**PLANNING DEPARTMENT ADMINISTRATIVE PUBLIC HEARING
SUMMIT COUNTY, UTAH
June 5, 2025**

Subject: 268 Main Street
Application: PL-25-06536
Author: Meredith Covey, Planner I
Date: June 5, 2025
Type of Item: Administrative Conditional Use Permit

Subject: 1328 Park Avenue
Application: PL-24-06312
Author: Lillian Zollinger, Planner III
Date: June 5, 2025
Type of Item: Historic District Design Review

Subject: 732 Crescent Road (Parcel PC-338-B)
Application: PL-22-05223
Author: Elissa Martin, Planning Project Manager
Date: June 5, 2025
Type of Item: Final Subdivision Plat for a Residential Lot

Requirement #5: Existing Historic Home and
 Proposed Addition on Existing Foundation
 Plus Restored Pre-Existing Front Yard Shed
 Plus Proposed New Backyard ~~Building~~ Accessory
 Building

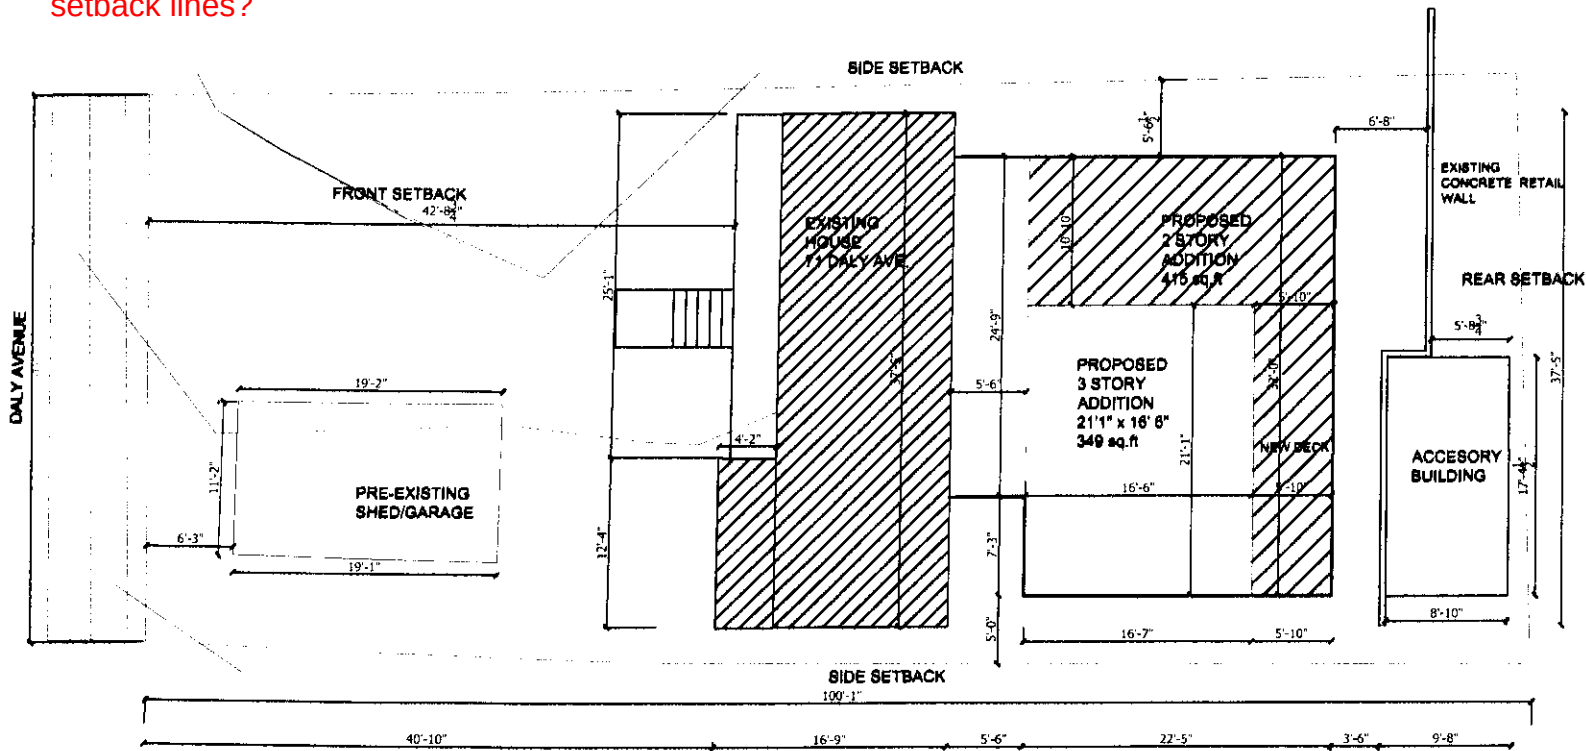
Missing property lines - have the
 property lines been mislabeled as
 setback lines?
